County of Santa Cruz

Subject: Public Hearing to consider appeal of the Planning Division's completeness determination for application #251393, a Coastal Development Permit to remove excess landslide debris from the bluff face and to construct debris flow fencing and drainage improvements behind an existing retaining wall in the rear yard.

**Attachment 5
Application 251393**

LANDSLIDE MITIGATION FOR ELAN & MAUREEN SHEINMAN 303 BEACH DRIVE, APTOS, SANTA CRUZ COUNTY, APN #043-082-70
GRADING & DRAINAGE PLAN

C-1

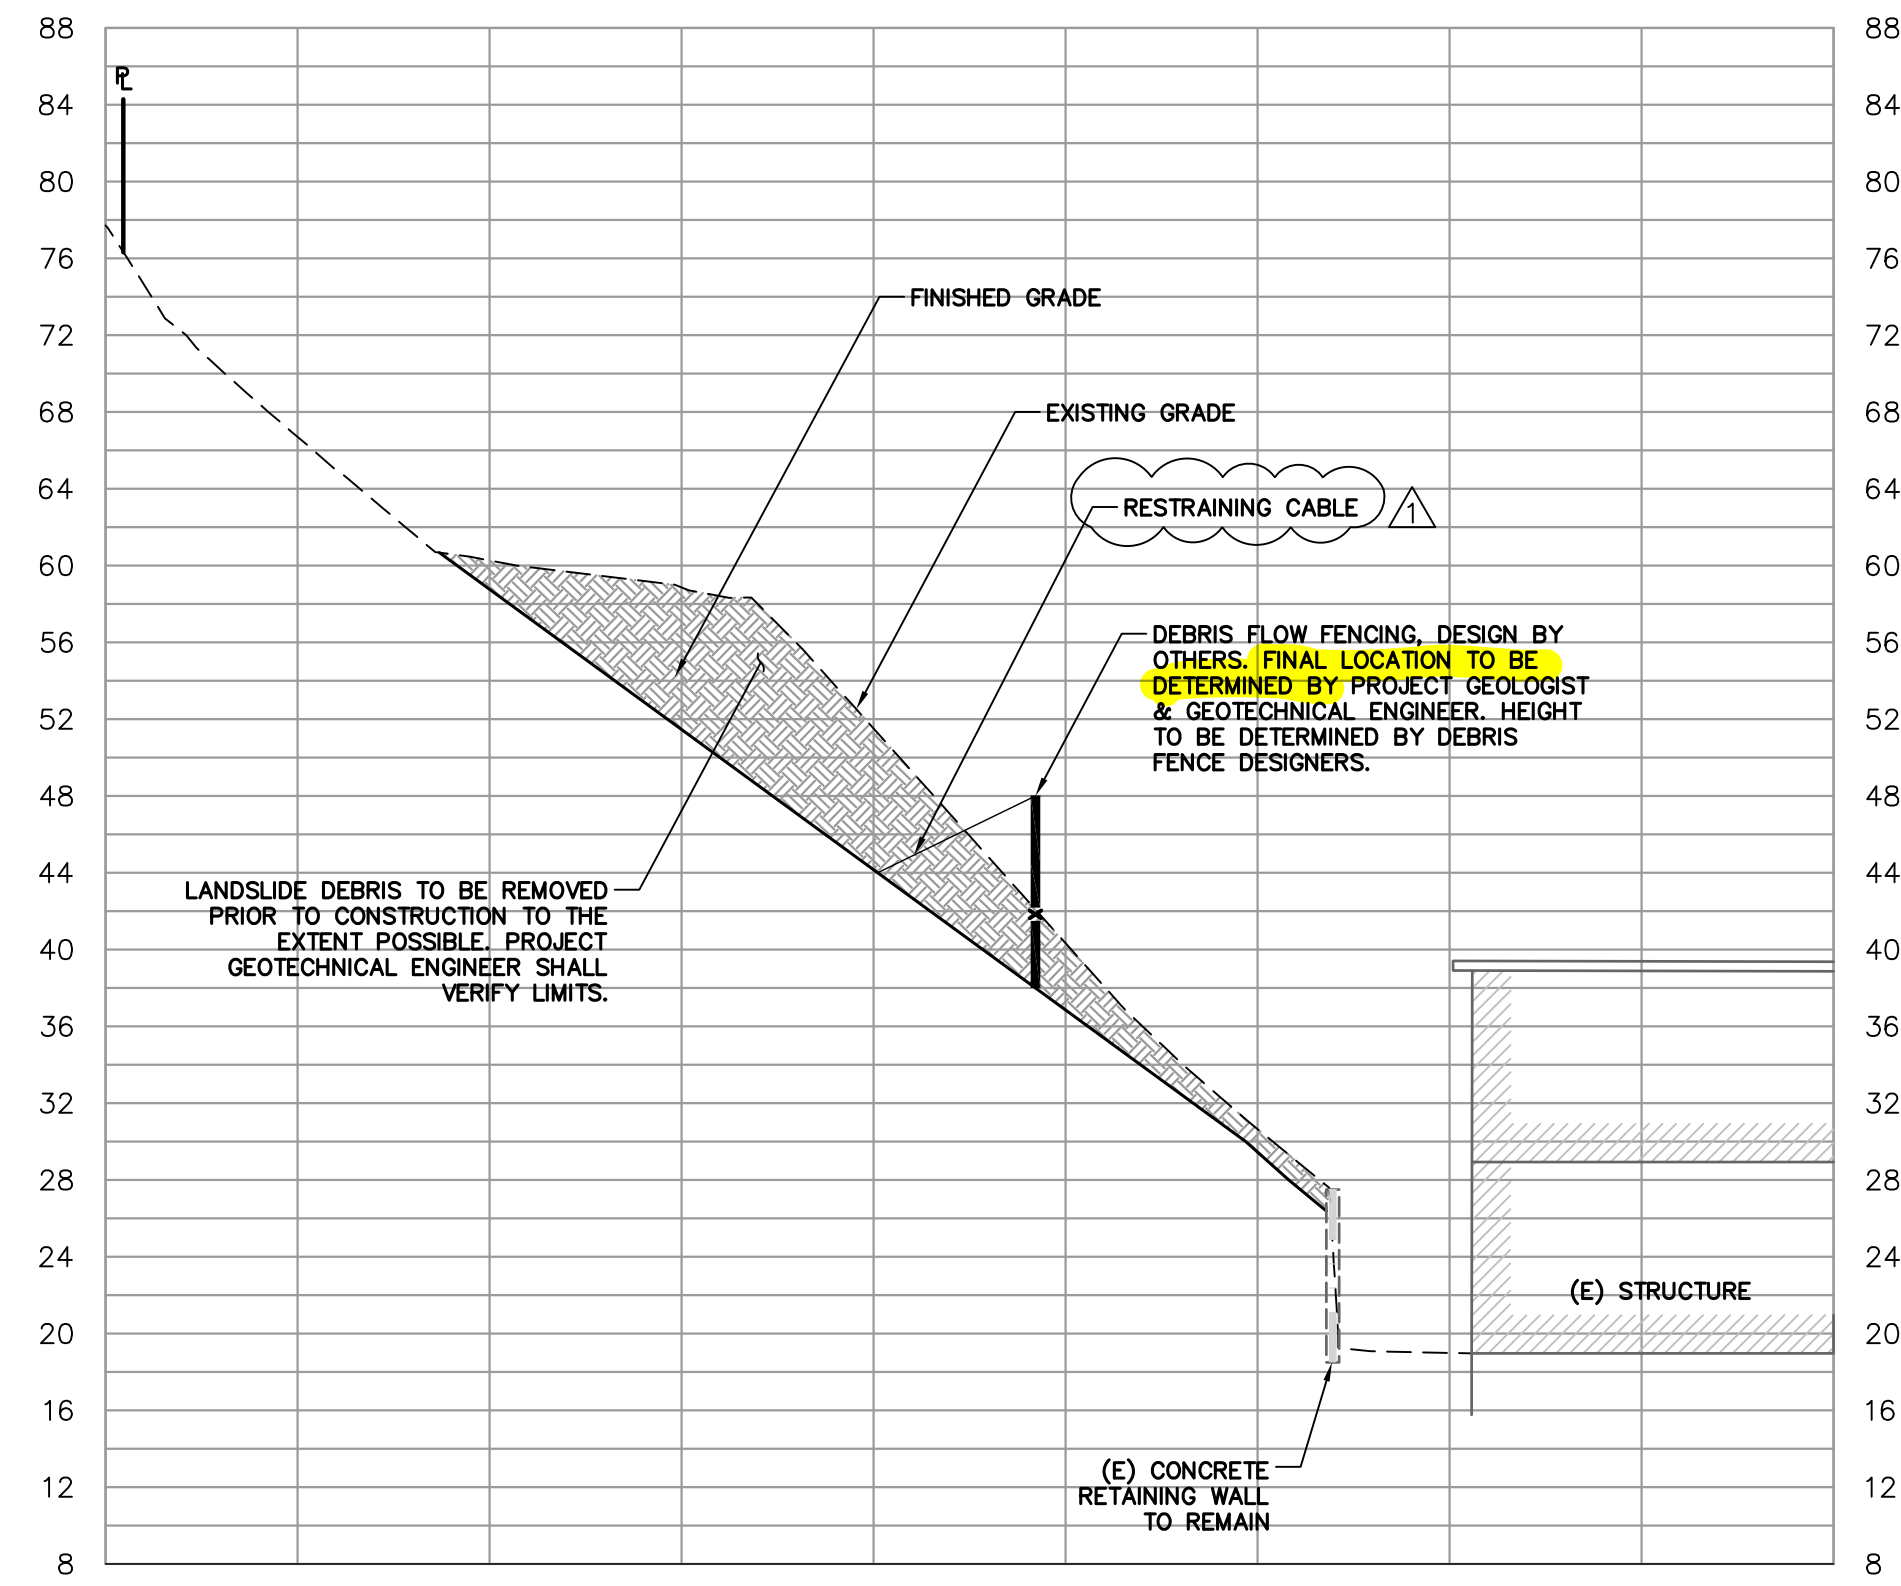
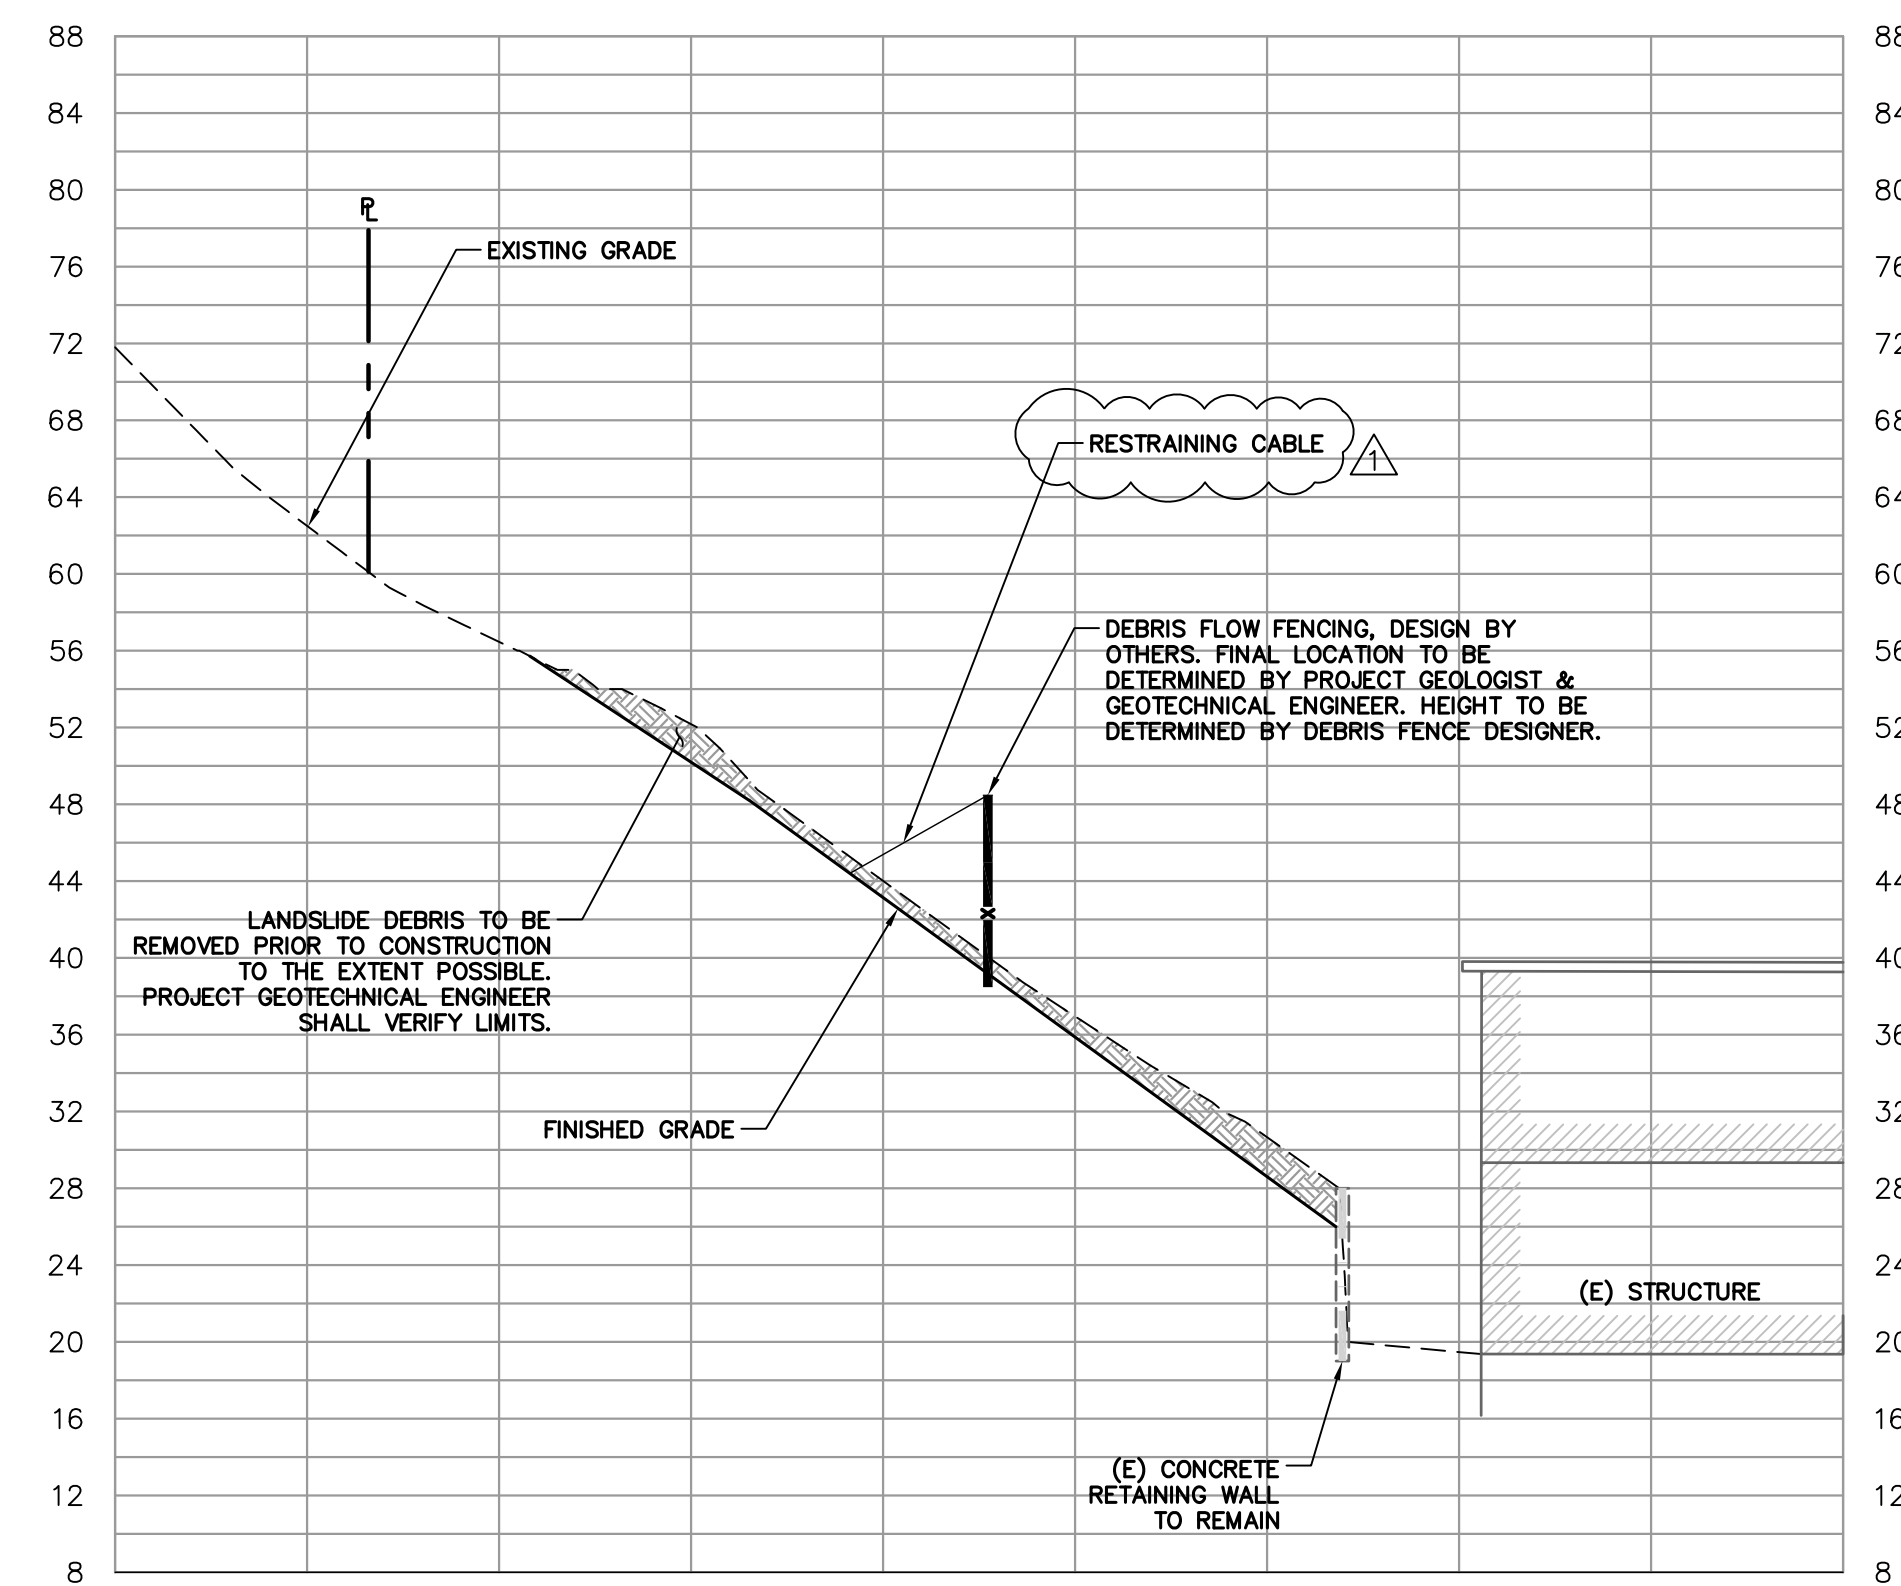
Please provide a modification worksheet and associated modification plan that clearly delineates demolition of existing exterior and interior walls at the garage/bathroom as needed to provide construction access as noted on sheet C-1 (note states "site access thru garage").

1. Please submit full and complete sets of revised plans which include the following information:
 - a. On C1 site plan, address the following:
 - i. Please show the R-1-6 zone district setback lines.
 - ii. Please provide clarification on the final project location. The site plan states the final location will be determined by the project geologist, but based on the debris fence labeling it will be 10-15 feet from the existing retaining wall.
 - iii. Please indicate the extent of area where erosion control netting is proposed to be installed.
 - iv. Please show clear boundaries of the proposed grading and disturbance areas.
 - v. Please clarify that improvements shown as “proposed” on adjacent APN 043-082-13 are not within the application’s scope of work.
 1. Please adjust the existing slope line to reflect current site conditions, as necessary.

- vi. Please include height measurements in addition to elevations for the existing retaining wall.
 - vii. Please clarify the nature of the dashed lines extending upslope from the fence structure.

- viii. Earthwork quantities are approximated at 100 cubic yards, which is inconsistent with the technical reports. Please update and/or clarify as needed.

- b. Please provide a construction/operation plan which includes the plans for equipment staging and employee parking at the site.
 - c. Please elaborate on planned access through the rear of the garage, including the extent of structural modifications.

b) Please provide a modification worksheet and associated modification plan that clearly delineates demolition of existing exterior and interior walls at the garage/bathroom as needed to provide construction access as noted on sheet C-1 (note states “site access thru garage”).

a. Please provide a modification worksheet and associated modification plan that clearly delineates demolition of existing exterior and interior walls at the garage/bathroom as needed to provide construction access as noted on sheet C-1 (note states “site access thru garage”).

Please provide a modification worksheet and associated modification plan that clearly delineates demolition of existing exterior and interior walls at the garage/bathroom as needed to provide construction access as noted on sheet C-1 (note states “site access thru garage”).
